SUBDIVISION REVIEW SHEET

CASE NO.: C8J-2018-0213.2A

SUBDIVISION NAME: Longview, Phase 2 - Final Plat

CITY OF AUSTIN – TRAVIS COUNTY – SINGLE SUBDIVISION OFFICE
SUBDIVISION APPLICATION – MASTER COMMENT REPORT

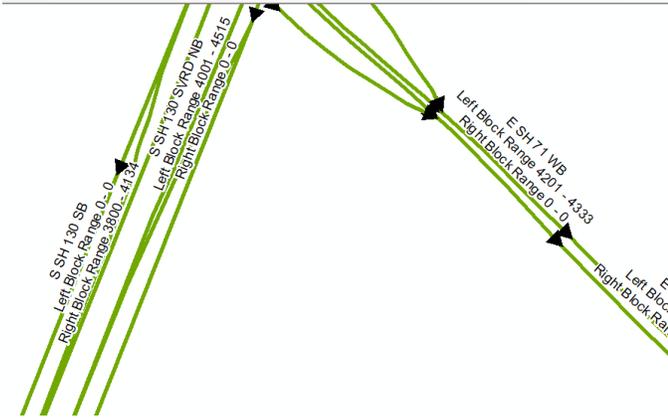
AD2: Please remove all forms of punctuation after abbreviating street types or directional including streets in the vicinity map

AD3: Please update label to read as follows **S SH 130** the directional S must be included in the vicinity map

AD3: Please update label to read as follows **E SH 71** the directional E must be included in the vicinity map

NOTE: E SH 71 is incorrectly labeled as HIGHWAY 71

NOTE: S SH 130 is incorrectly labeled as I 130

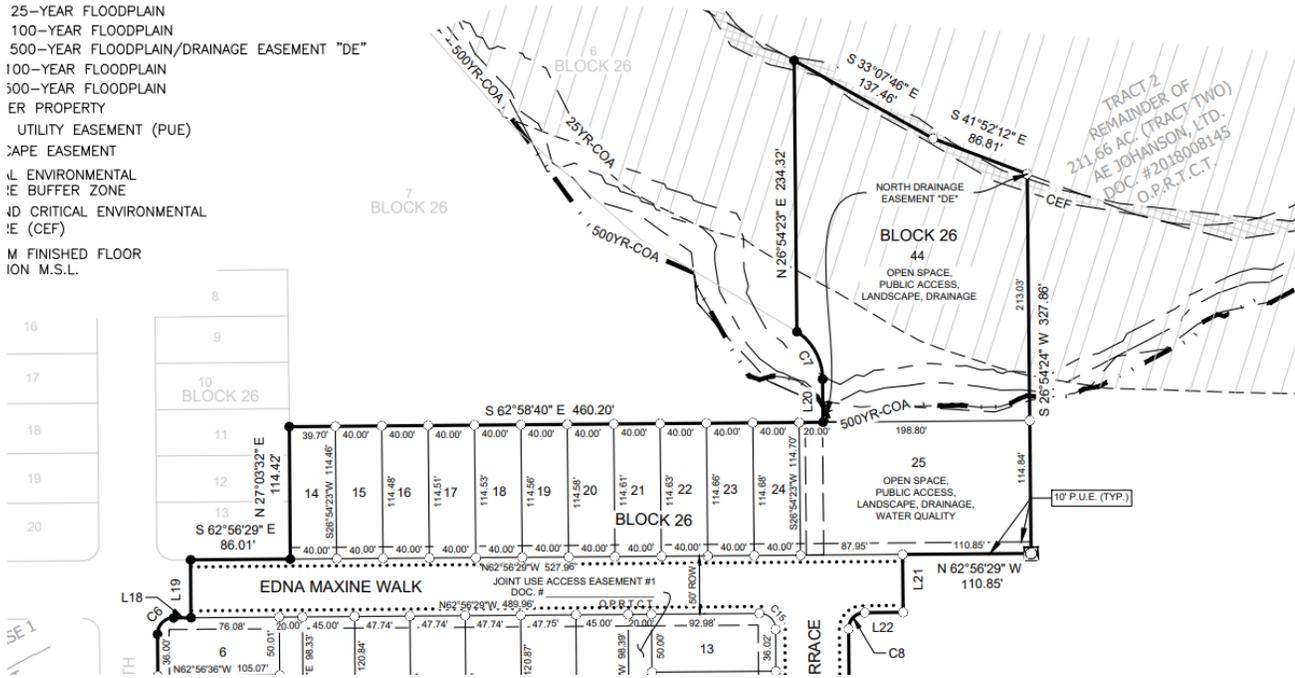
FP3: It appears from property profile that there is FEMA A zone on your lots which is not shown. Please delineate the FEMA Floodplain on plat. If property profile is incorrect, please provide exhibit showing that current FEMA A zone is contained to proposed Drainage Easement. If FEMA current Floodplain is NOT contained to drainage easement, please follow instructions in LDC 25-7-33E/30-4-33E. See the screenshots below.
